Technical Service Information

FORD 5R110W *Torqshift* **LOW DIODE FAILURE**

Figure 1

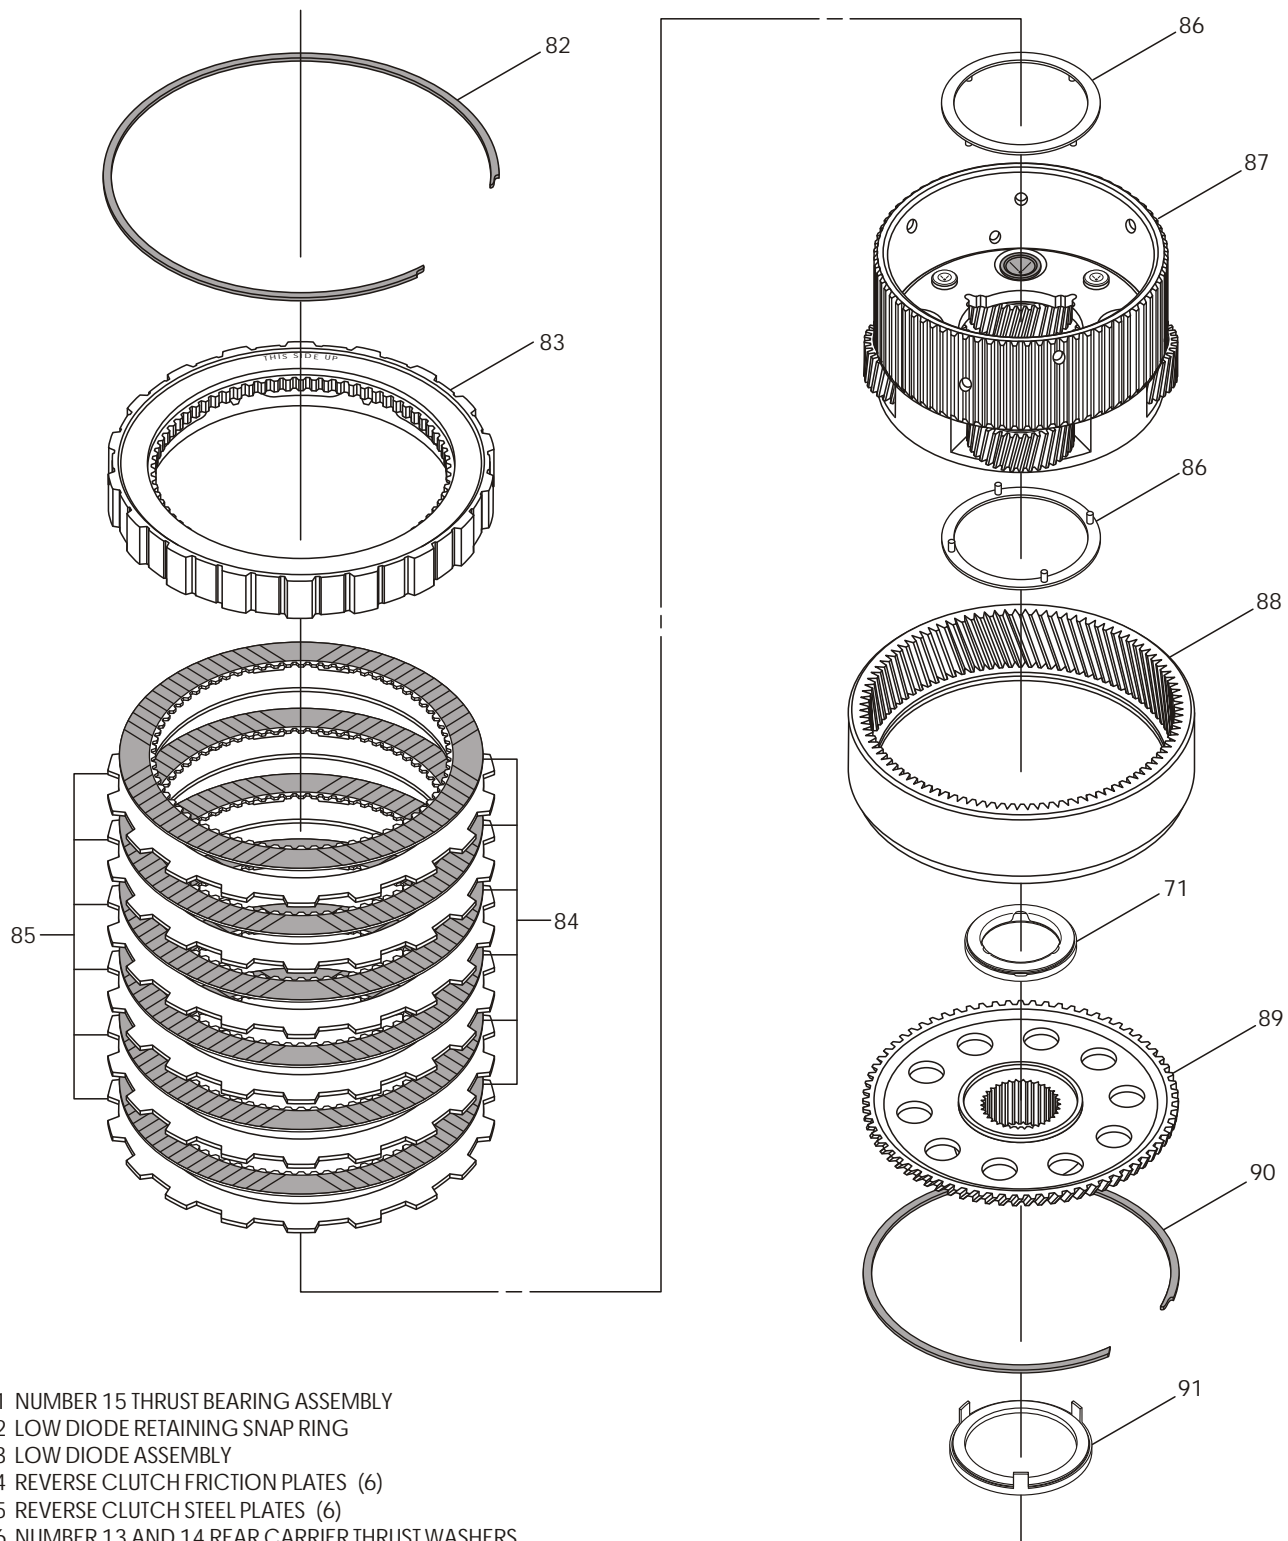
CHANGE: The Low Diode assembly has been changed very early in the 2003 production year with a material change and very small dimensional changes. Exploded view of the low/reverse clutch parts is provided for you in Figure 1.

Figure 2

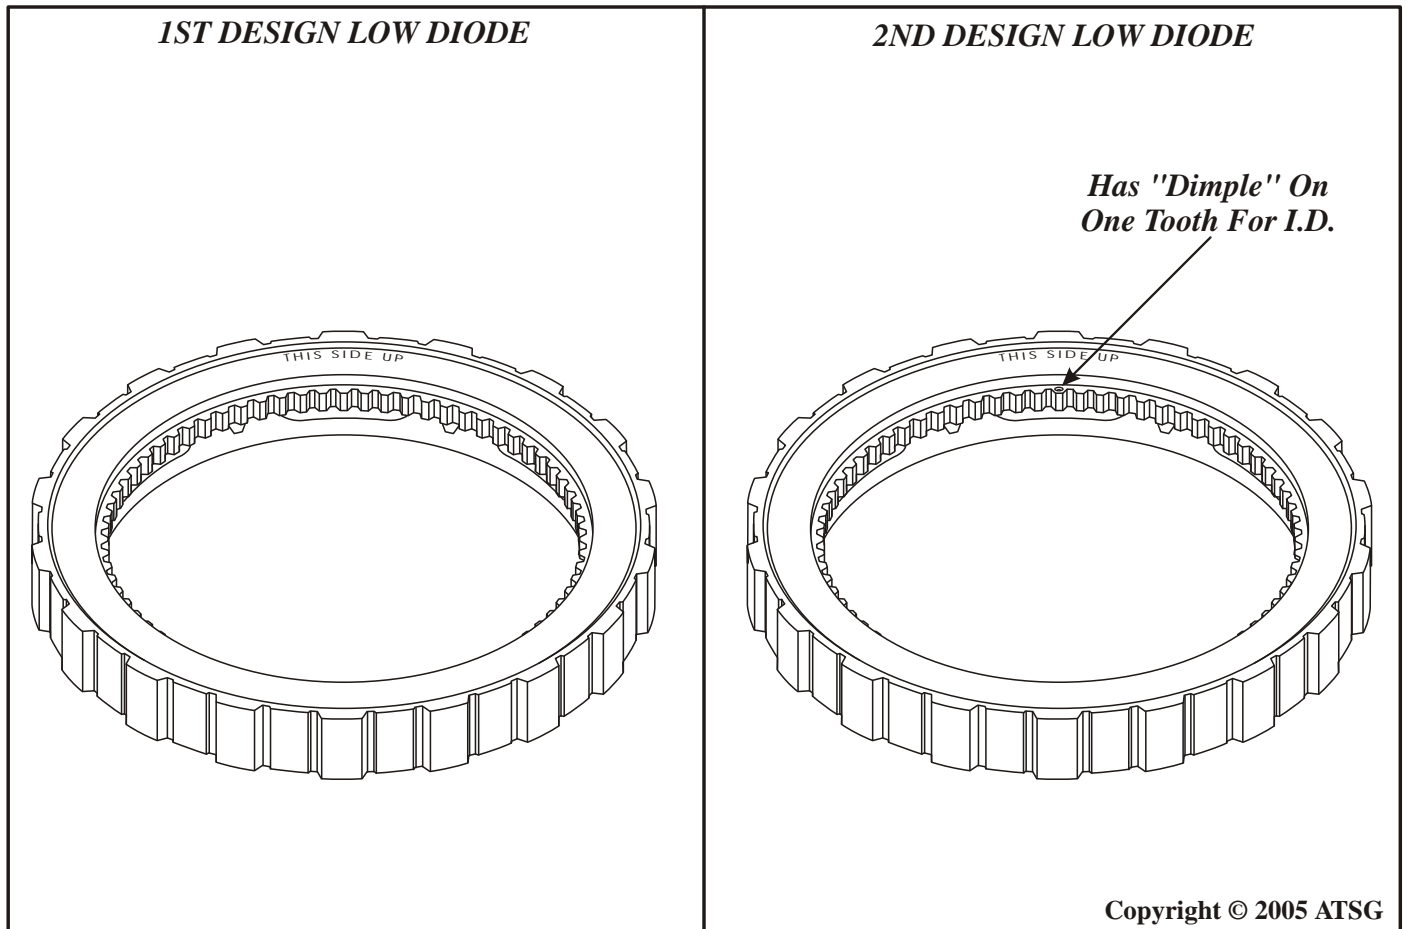
- (1) LOW DIODE ASSEMBLY - Recieved a material change on all pieces of the low diode assembly and a small "Dimple" was added to one tooth of the inner race for identification, as shown in Figure 2.

Will retro-fit back on all model years. Do not use a low diode that does not have the small identification "Dimple" on one tooth of the inner race, as shown in Figure 2.

Low Diode Assembly (2nd Design) 3C3Z-7A089-AB
